SUBMITTAL OF HANFORD FACILITY RESOURCE CONSERVATION AND RECOVERY ACT (RCRA) PERMIT MODIFICATION NOTIFICATION FORM 24590-HLW-PCN-ENV-06-013

**Hanford Facility RCRA Permit Modification Notification  
Form 24590-HLW-PCN-ENV-06-013**

Page 2 of 3: Hanford Facility RCRA Permit, Part III, Operating Unit 10, Waste Treatment and Immobilization Plant  
Update HLW Vitrification Building Piping and Instrumentation Diagrams (P&IDs) for the HLW Canister  
Decontamination Handling System (HDH-VSL-00001, HDH-VSL-00002, HDH-VSL-00003 and HDH-VSL-  
00004) in Appendix 10.2 of the Dangerous Waste Permit.

**24590-HLW-M6-HDH-P0001**

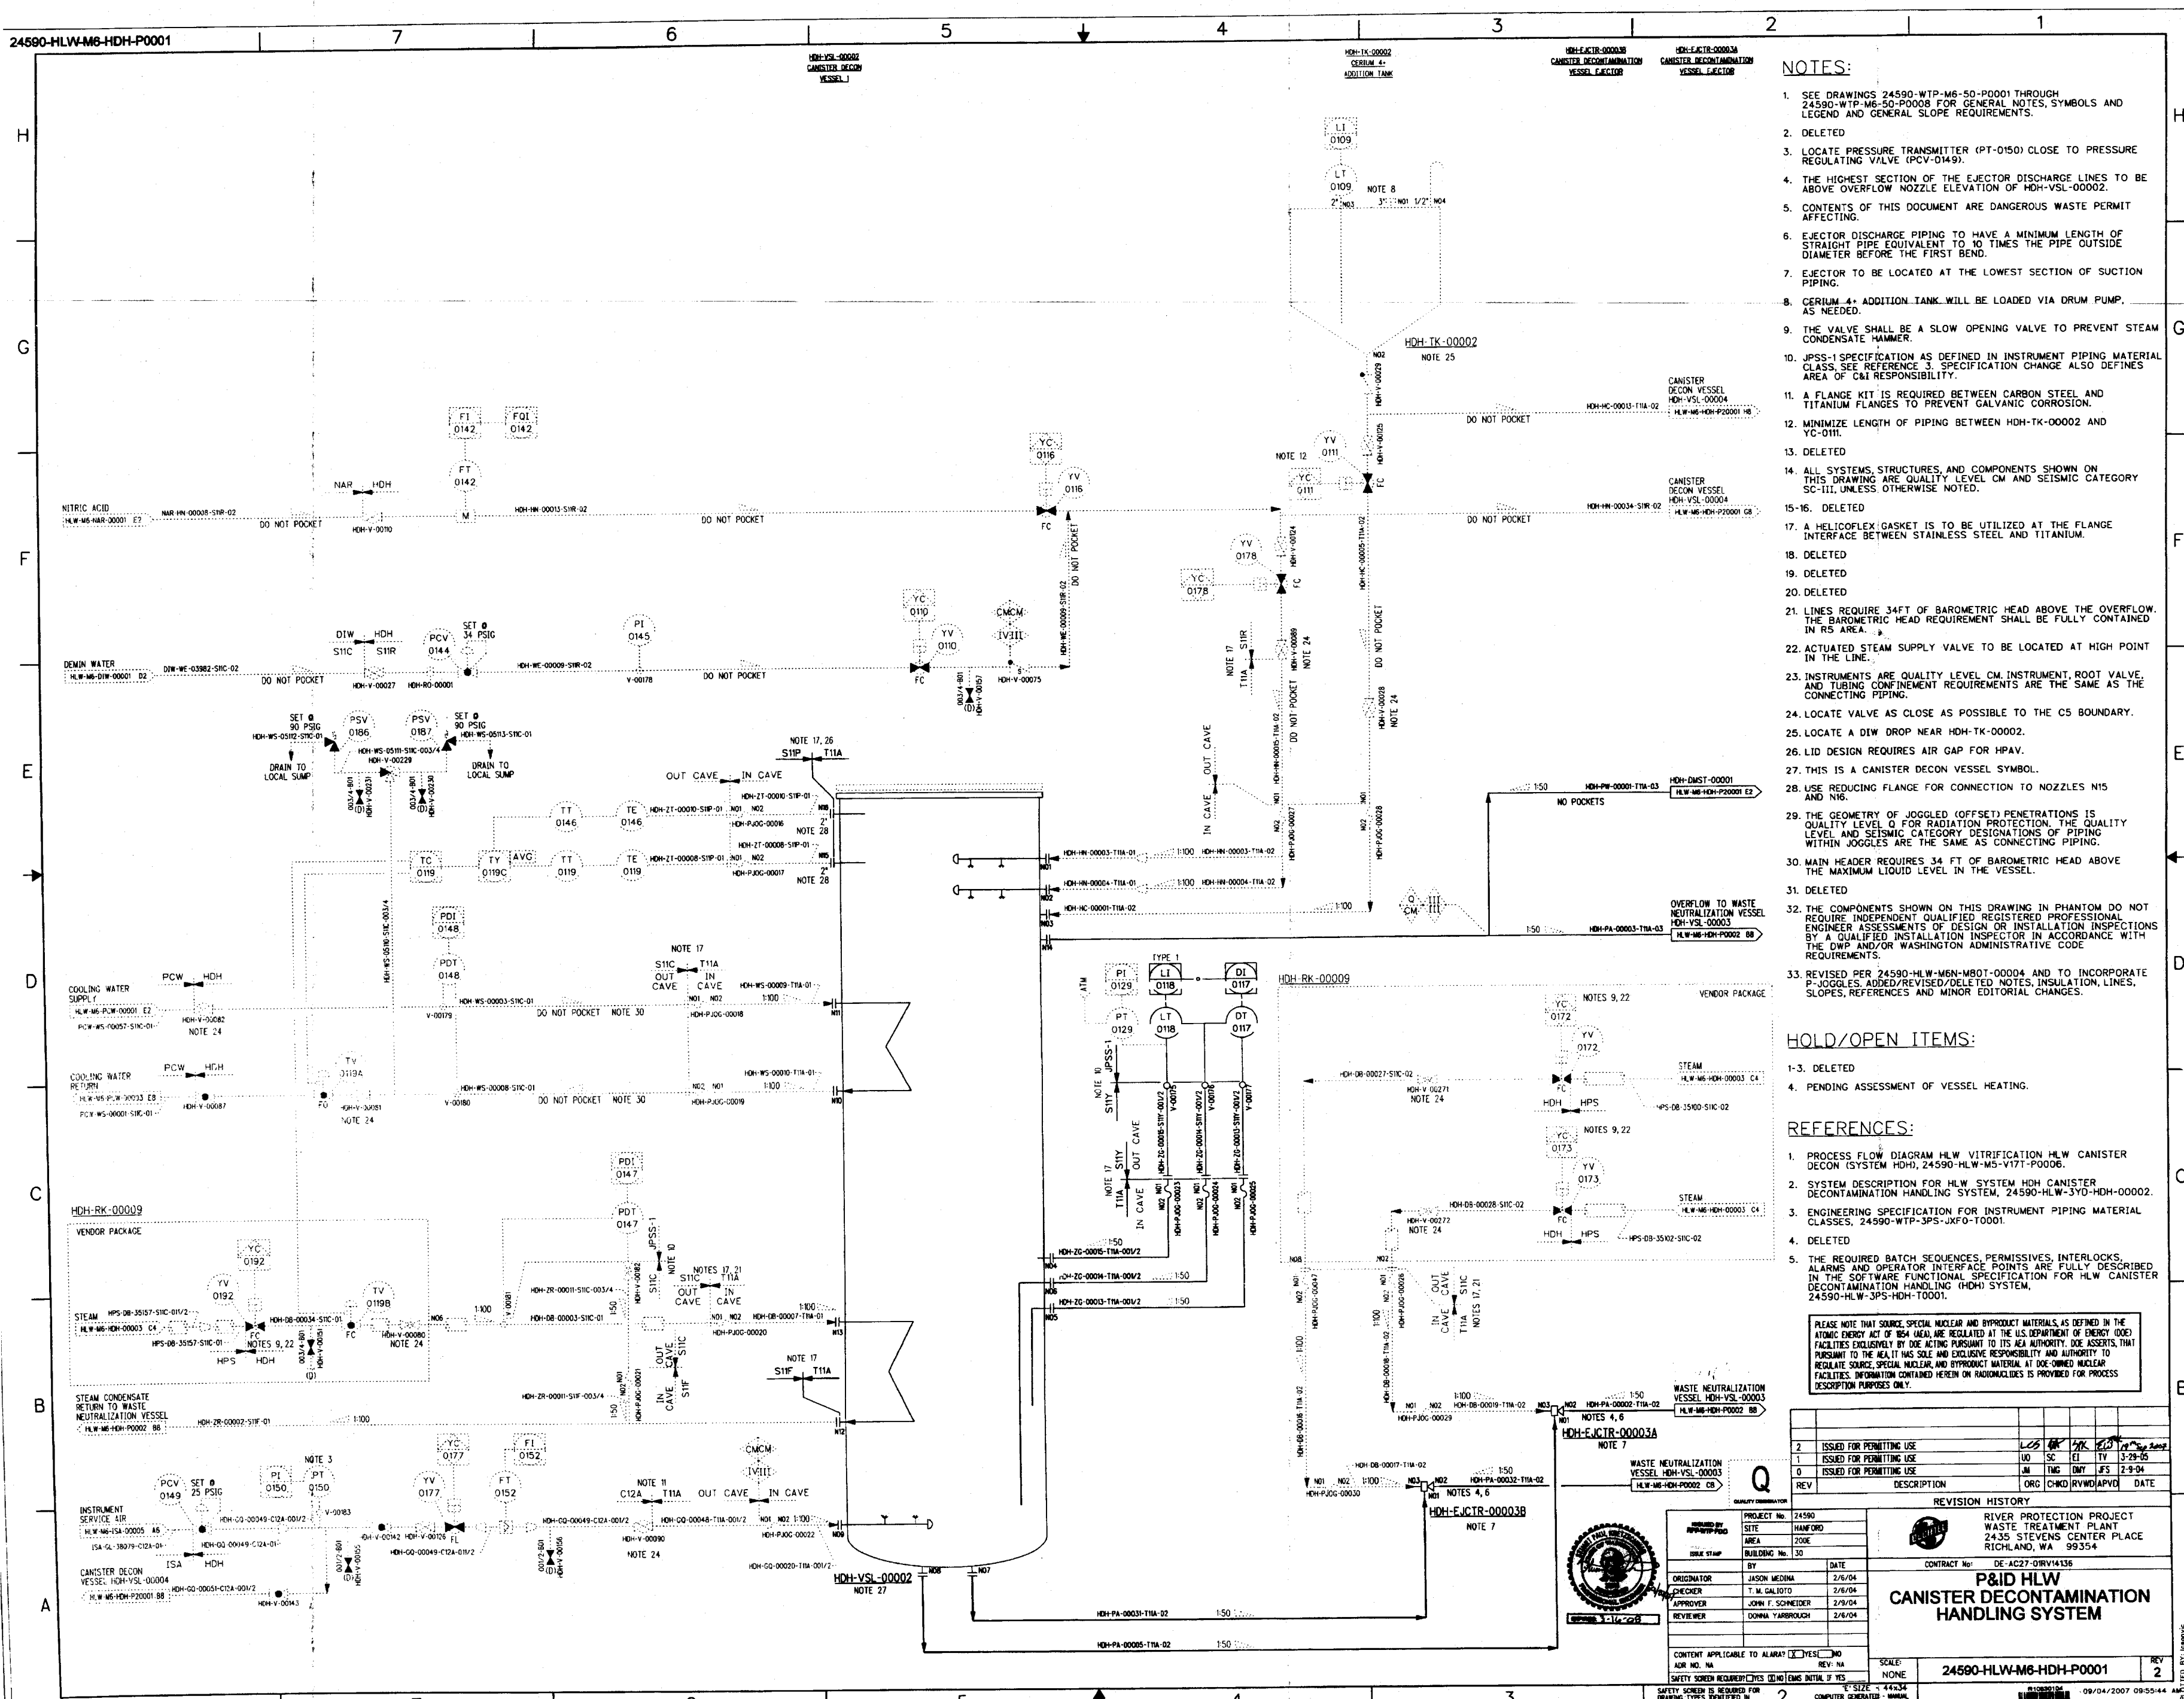
Specific changes to this P&ID are provided on note 33.

- Revised slope notation to specific lines
- Added, revised, and deleted notes, holds, and references
- Revised various off-sheet connectors and/or descriptions
- Revised through wall penetration designations from wall boxes to p-joggles
- Combined overflow line vents (HDH-VSL-00002 and HDH-VSL-00004) and routed to PJV Header through demister (HDH-DMST-00001)
- Revised various quality/seismic identifiers
- Revised and added line identification numbers.

- REVISED PER 24590-HLW-MEN-M807-00004 AND TO INCORPORATE P-JOGGLES, ADDED/REVISED/DELETED NOTES, INSULATION, LINES, SLOPES, REFERENCES AND MINOR EDITORIAL CHANGES.

**24590-HLW-M6-HDH-P0002**

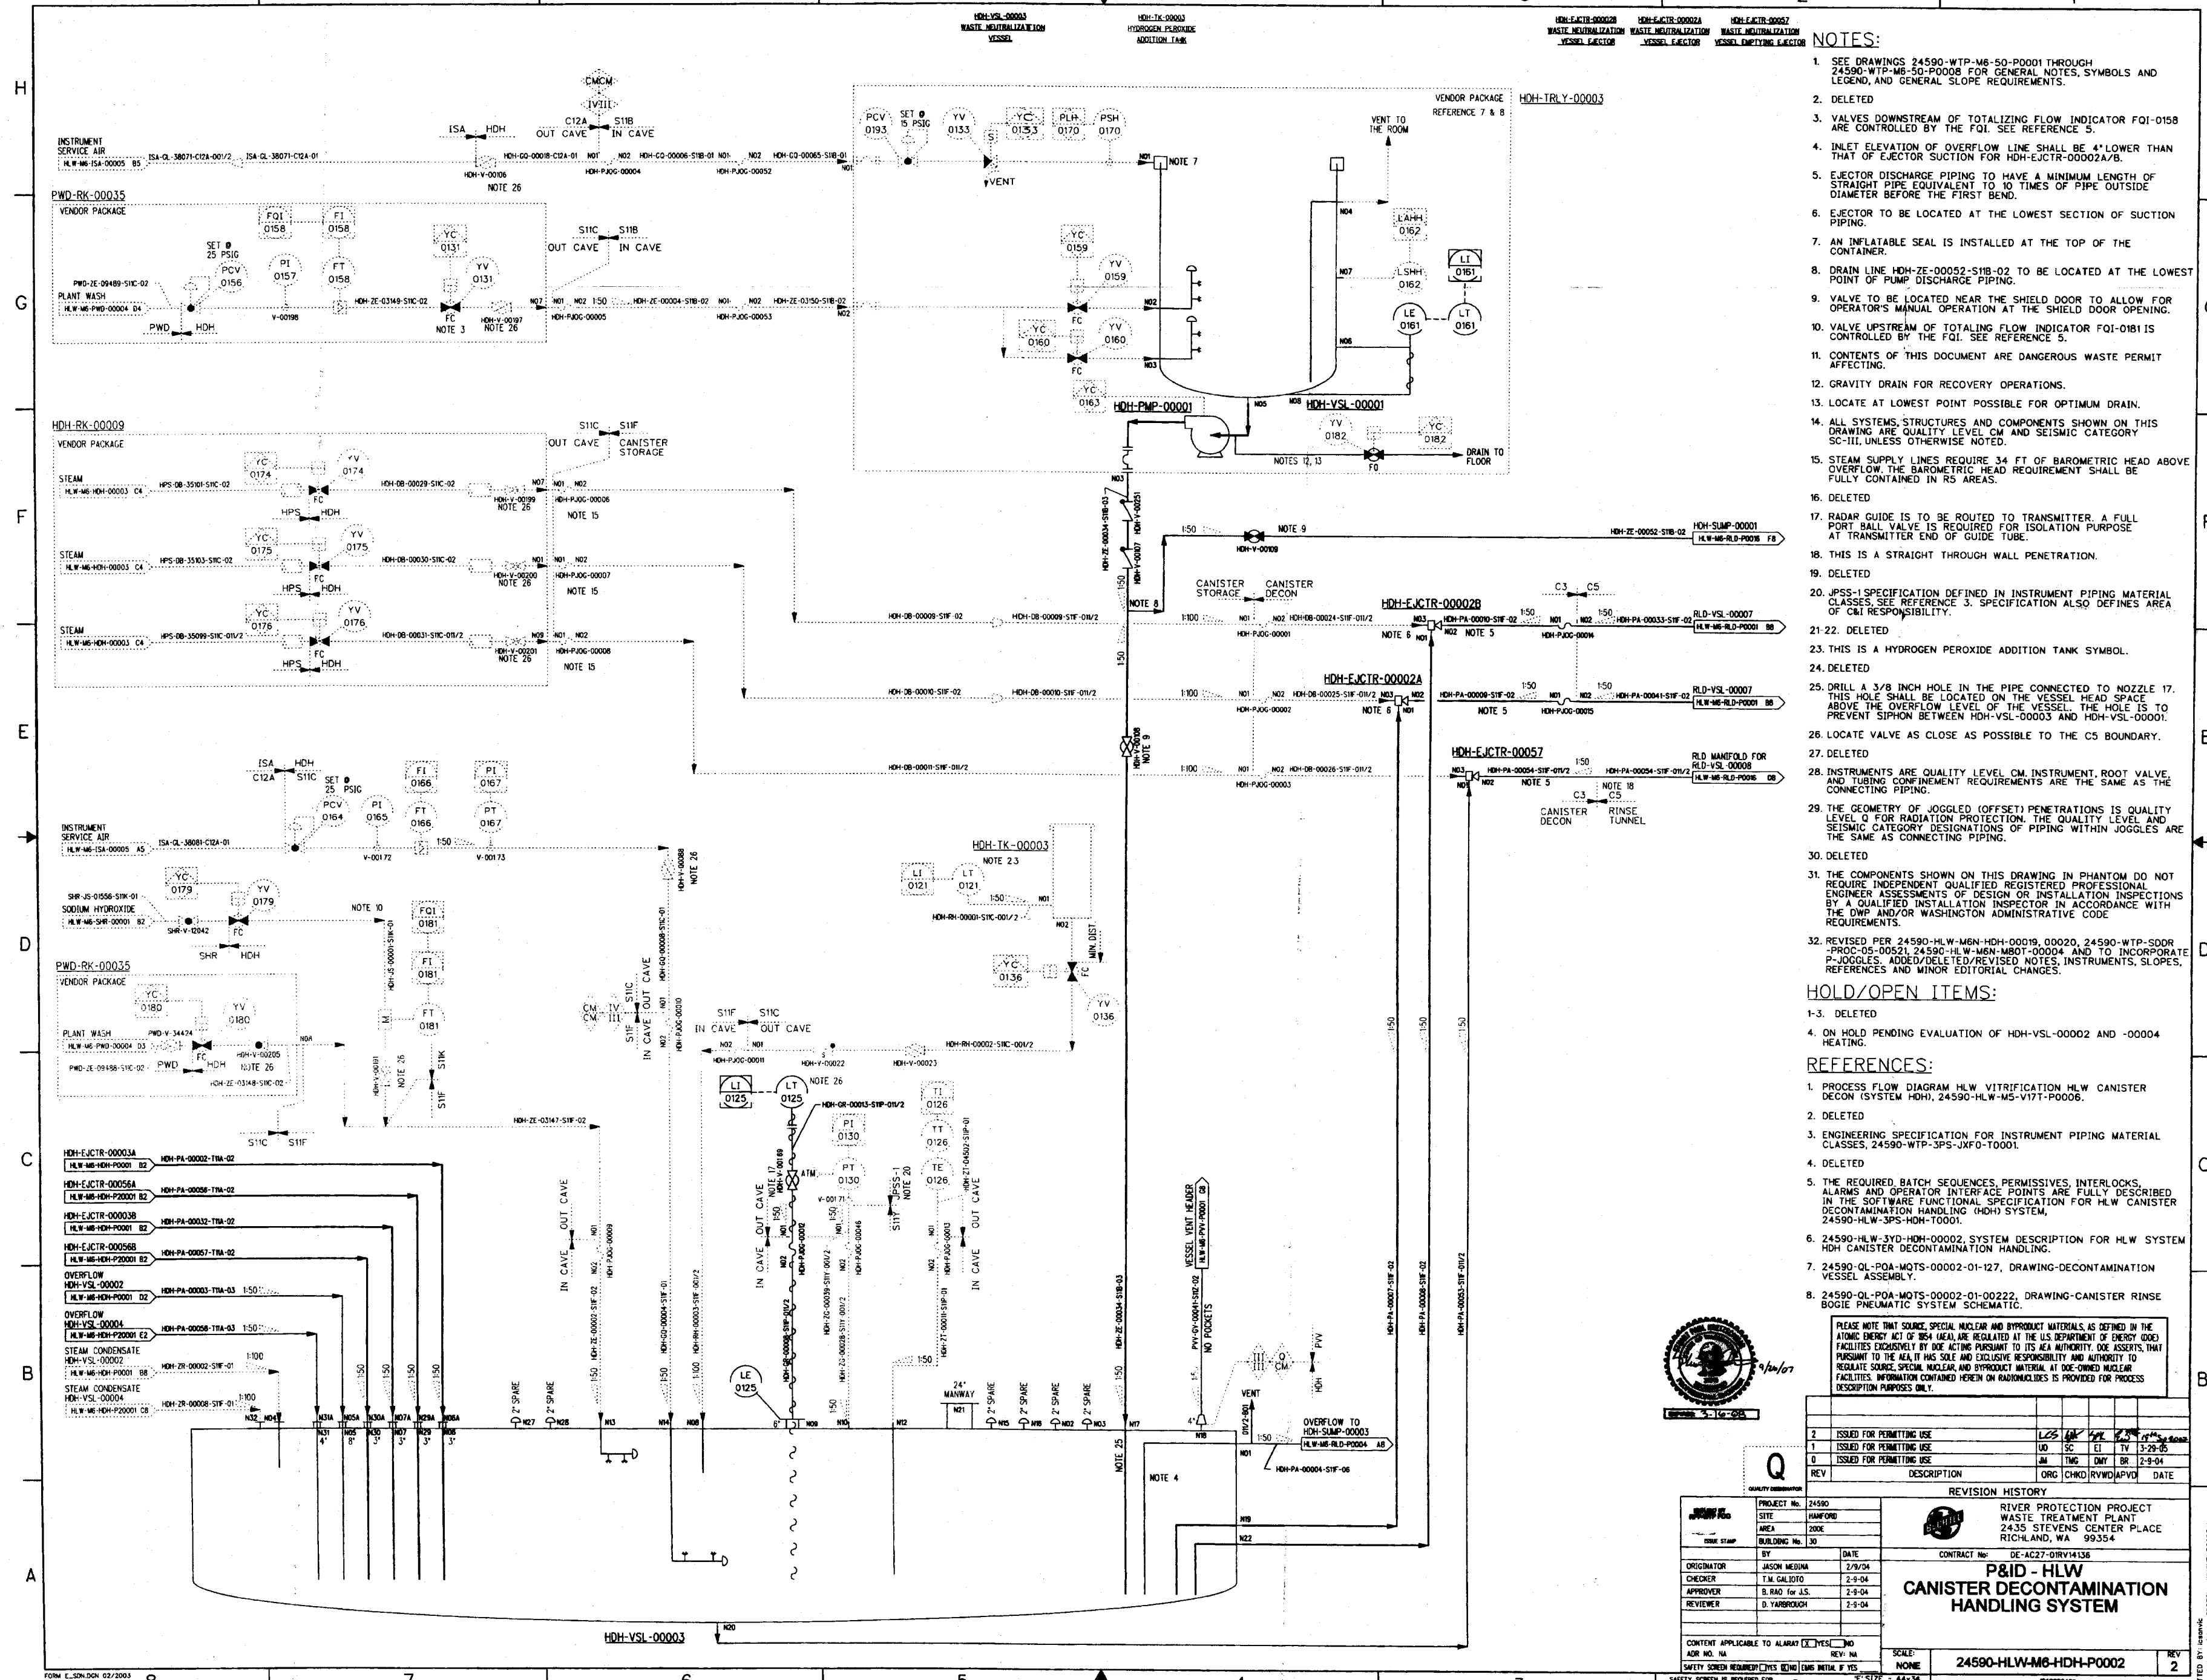
Specific changes to this P&ID are provided on note 32.

- Revised slope notation to specific lines
- Added, revised, and deleted notes, holds, and references
- Revised various off-sheet connectors
- Revised through wall penetration designations from wall boxes to p-joggles
- Added level element LE 0125 (coordinates B6)
- Added check valves HDH-V-00107 and HDH-V-00251 (coordinates F4)
- Revised various quality/seismic identifiers
- Revised and added line identification numbers.

- REVISED PER 24590-HLW-MEN-HDH-00019, 00020, 24590-WTP-SDDR-PROC-05-00521, 24590-HLW-MEN-MB07-00004, AND TO INCORPORATE P-JOGGLES, ADDED/DELETED/REVISED NOTES, INSTRUMENTS, SLOPES, REFERENCES AND MINOR EDITORIAL CHANGES.
